East Chatteris Broad Concept Plan (BCP) – Comments received from Consultees

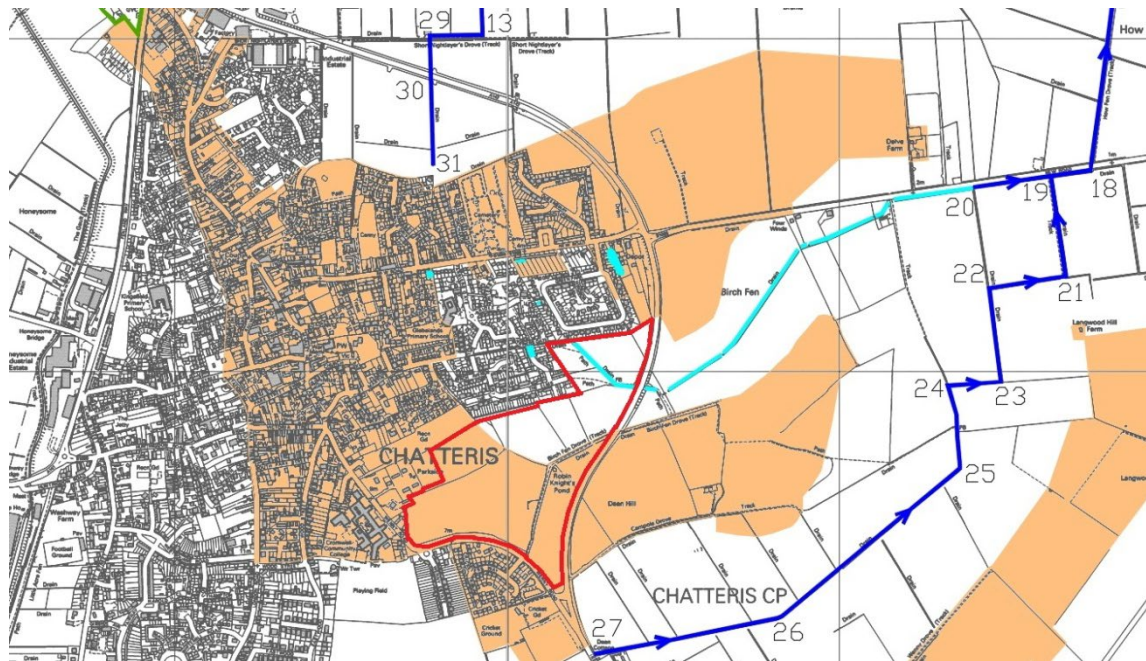
The site's extent is partly within the Board's highland catchment hatched brown on the plan, below, and the Board's rateable area, edged green.
